BUILDING COMPLETION REPORT

With reference to your application dated 3-8-38
with a plan for the proposed buildings/additions and alterations on plot
No. 20/4 Survey Sheet No. T.M.3 Jamshed Quarter,
I have to request you to comply with the following requirements:—

AMENDED PLAN OF PLOT NO 20/4 J.MR. JAMSHED Q.

THE COSMOPOLITAN CO-OPERATIVE HOUSING SOCIETY.

242.00 + 325.53 = 567.53 SQ. YD.
567.53 - 150.60 = 416.93 SQ. YD.
(417.43 SQ. YD.)

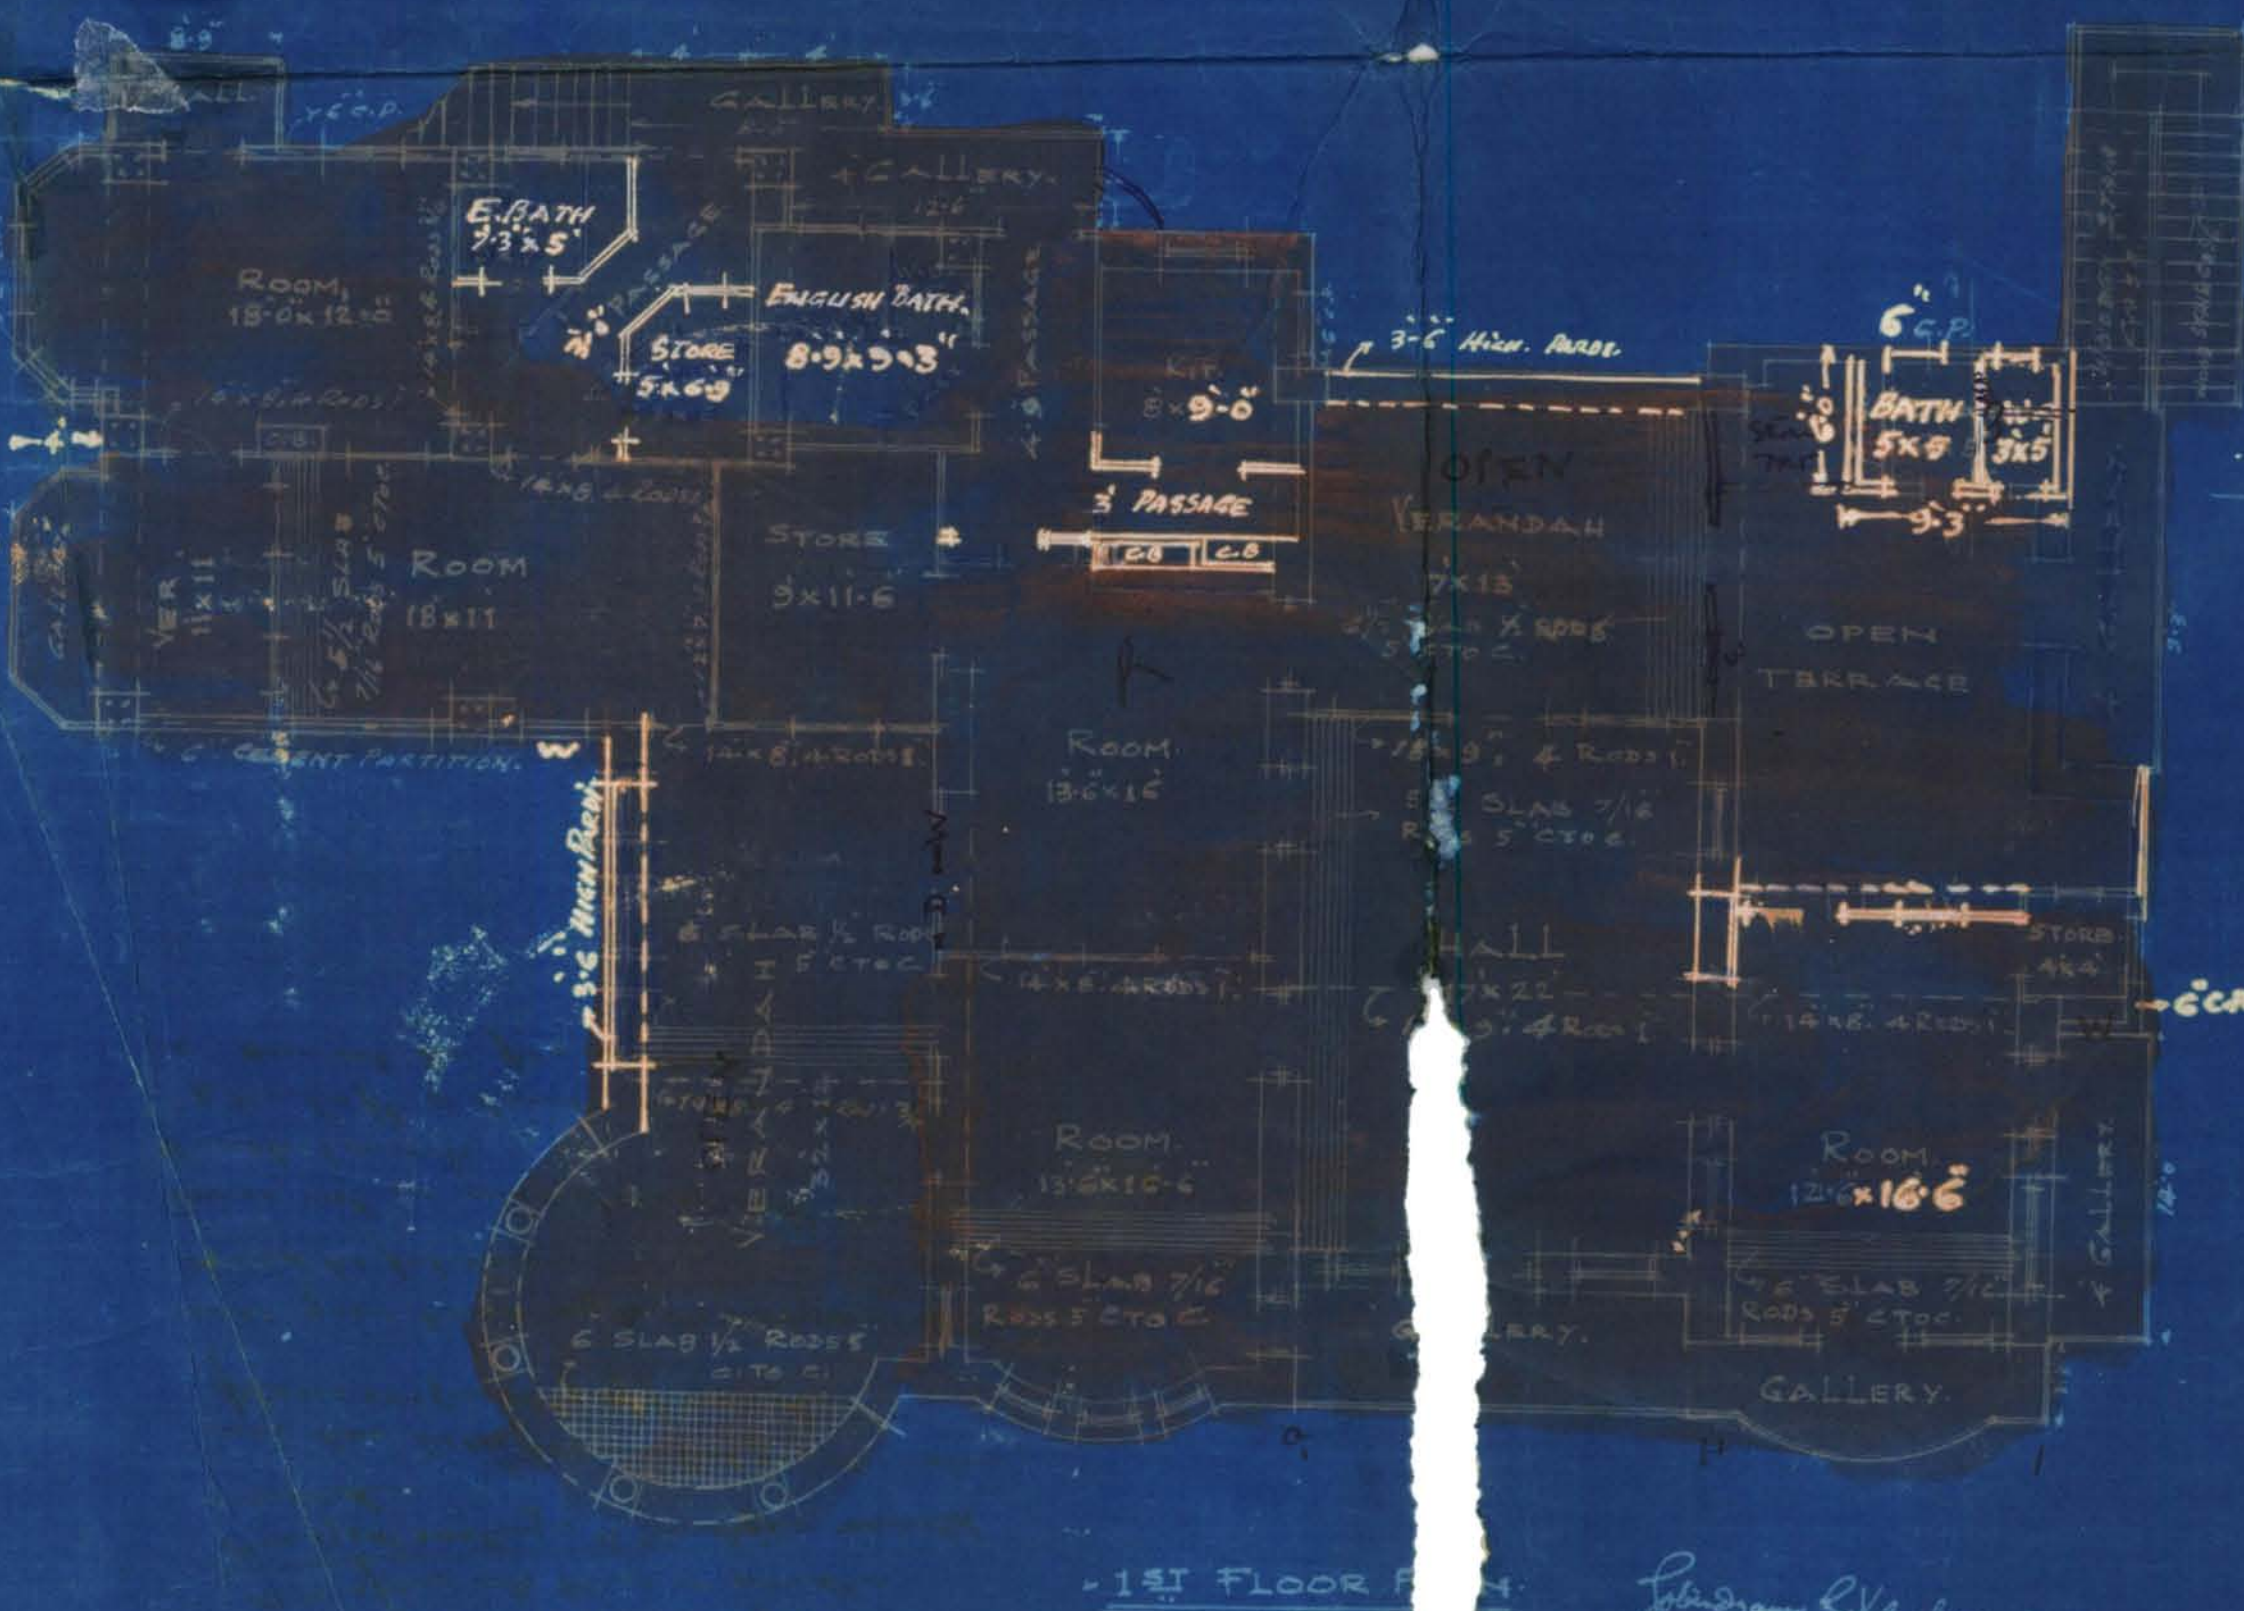
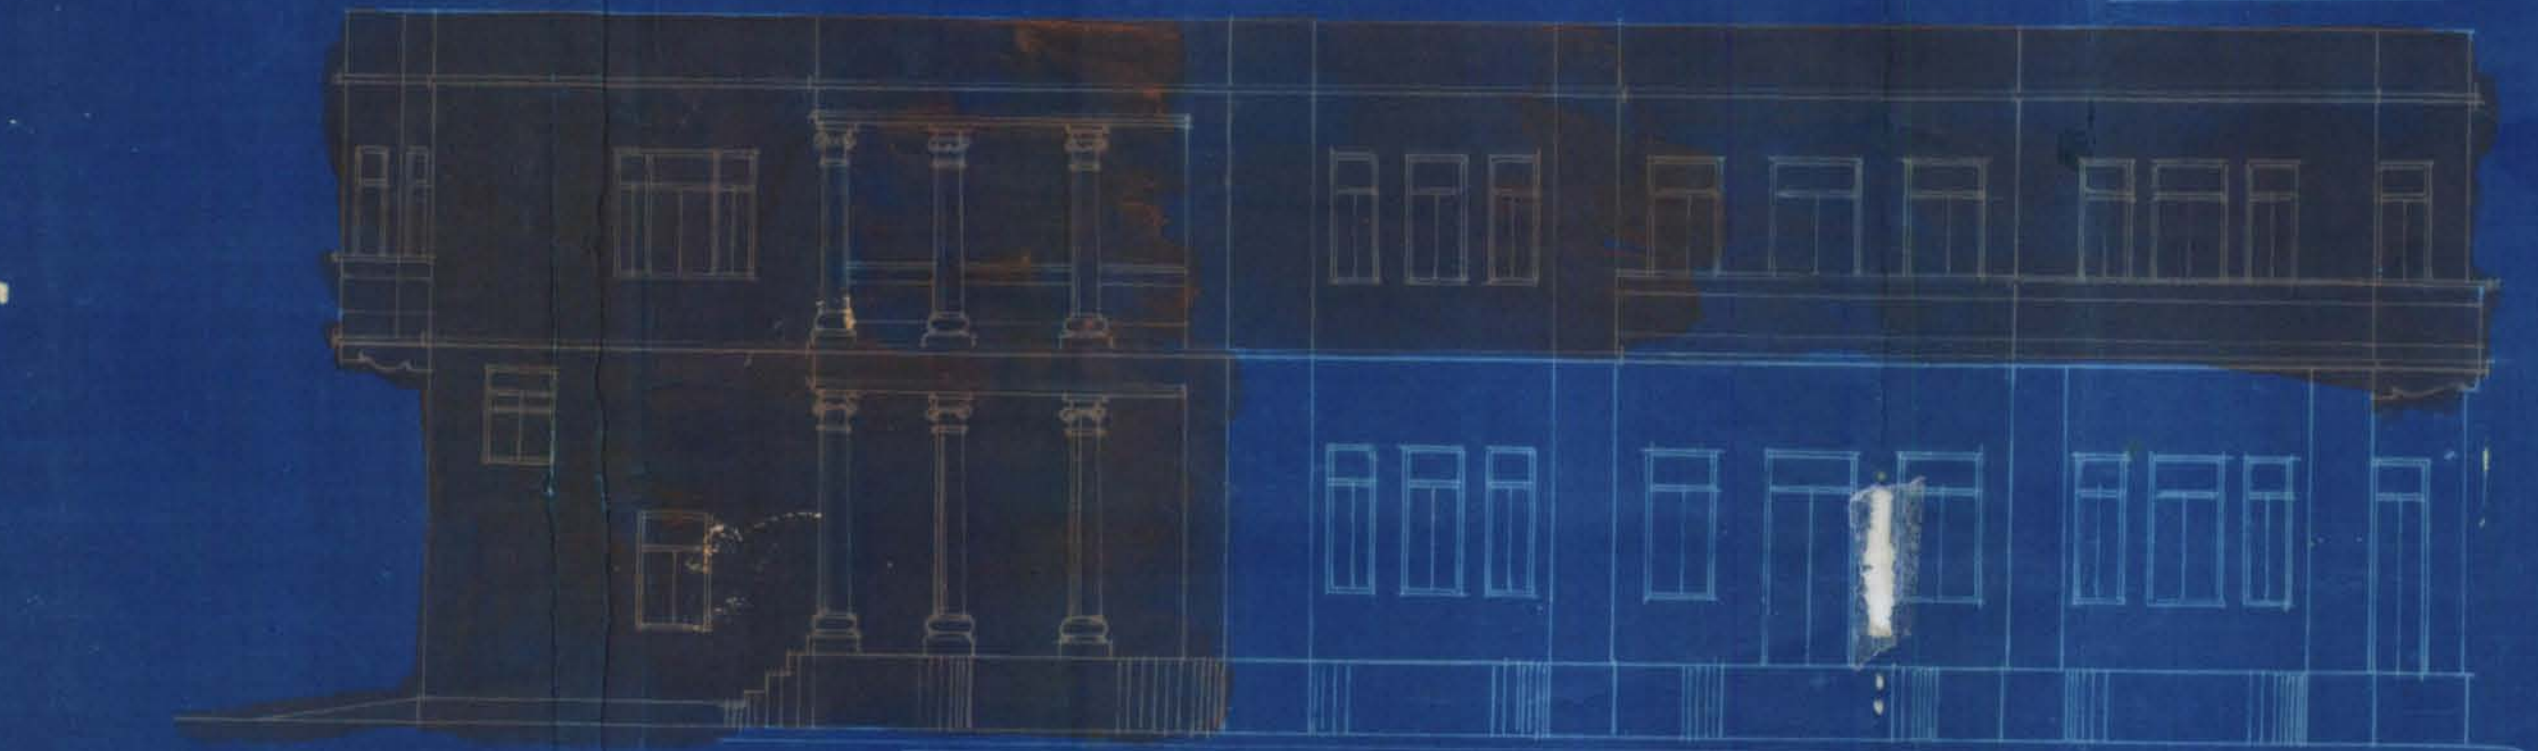
1. Objection No. 2. Stairs.

2. " " 5 & The Architect has not checked

3. Re Objection No. 6. The court yard cannot be

The compulsory open should not be
encroached upon.

4. The height of W.C. A. should be 8'-0"

The room is not properly ventilated. The
verandahs are covered roof. as the
rooms and the room in question will
have no access to air & light.

Unauthorized railings to the lofts should
be removed.

The owner has been prosecuted for deviations
from plans originally approved.

Distance from boundary to the staircase on the
south should be put down.

The plan is not in accordance with the structure
constructed on site.

Door to the loft & landing attached to the
same cannot be permitted.
